Field Safety Notice (FSN)

SpiroScout“SP Plus”

Date: 2023-02-16

Service Note Nr. / CHANGE NR.		QI-69	Issue date: 2023-02-07
Product:	SpiroScout SP plus	<input type="checkbox"/> Software	<input checked="" type="checkbox"/> Hardware
Version:	N.A.	<input type="checkbox"/> initial	<input type="checkbox"/> follow-up

Information:

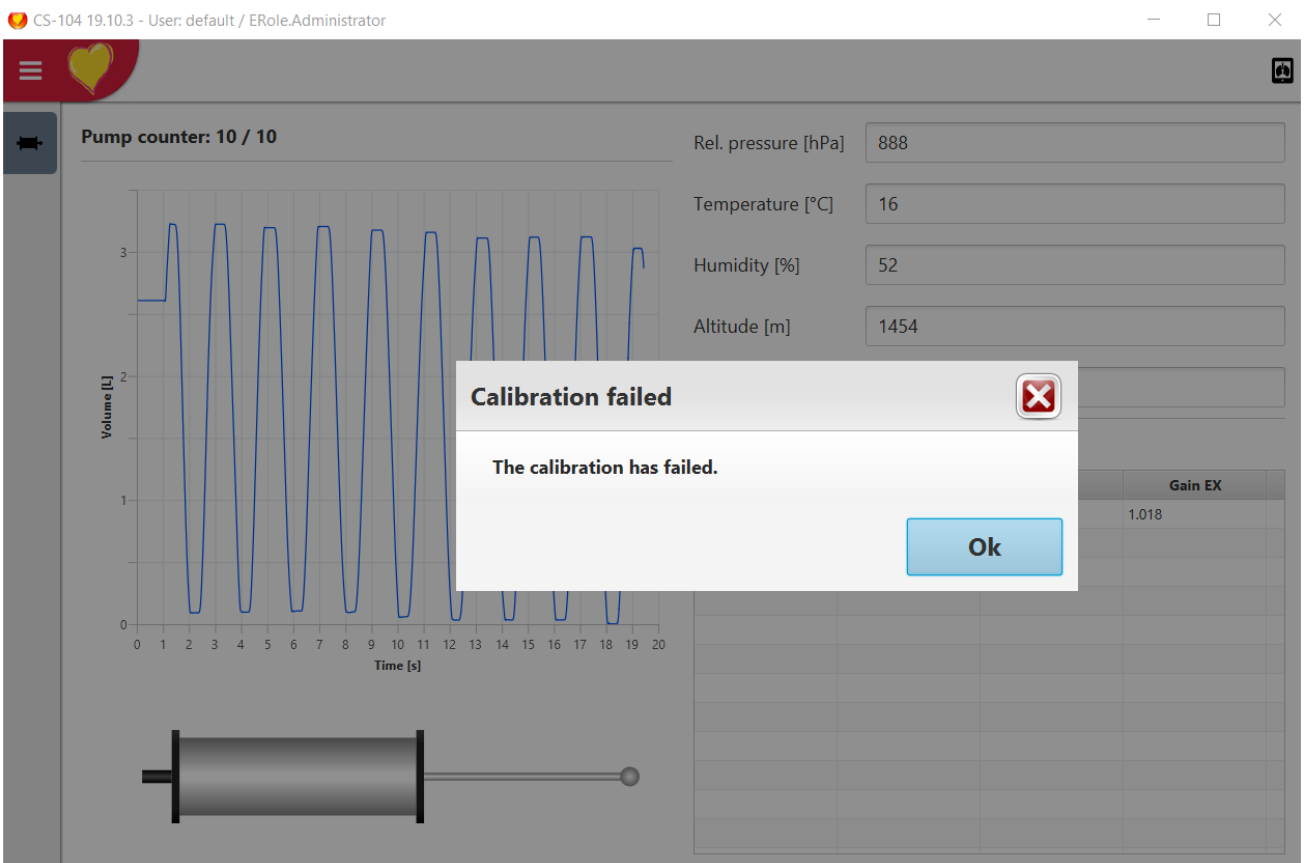
If there are problems with the SpiroScout SP plus volume verification [see picture], it is recommended to check the calibration factors.

Check the SpiroScout SP plus volume calibration factors with the "SpiroScout SP plus Configuration Tool". See separate instructions „Ganshorn.SPplusConfigurationTool.pdf“.
